# Americans with Disabilities Office General Services Department

## Accessibility Survey

**Location: 13<sup>th</sup> Street between Courthouse and Public Service Center**

### Item 1

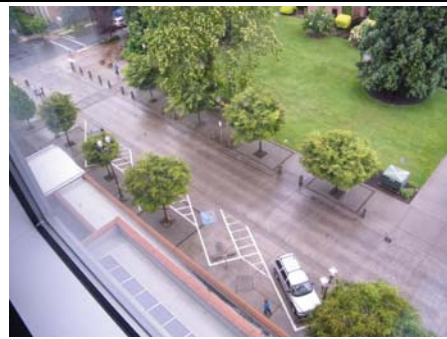
Issue: Accessible Route – Not clearly identified

Code IBC 1104.1 Site arrival points – Accessible routes within the site shall be provided from public transportation stops, accessible parking and accessible passenger loading zones and public street or sidewalks to accessible building entrance.

Code IBC 1104.3 Connected Spaces – when a building, or portion of a building, is required to be accessible, an accessible route shall be provided to each portion of the building, to accessible building entrances connecting accessible pedestrian walkways and the public way.

Code IBC 1104.5 Location – Accessible routes shall coincide with or be located in the same area as a general circulation path.

Recommendation: See Item 2

### Item 2

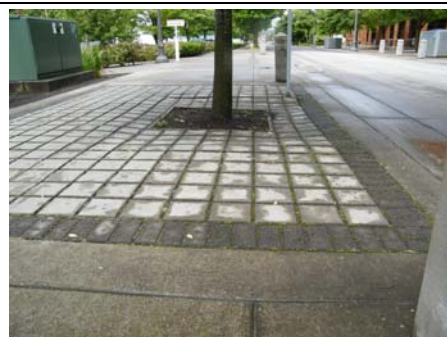
Issue: No demarcation between sidewalk and street. No curbs. Sidewalk is flush with street.

Code: IBC 1102

Recommendation:

Install barriers between bollards to prevent crossing of street at non-designated areas. Install additional bollards and barriers where required.
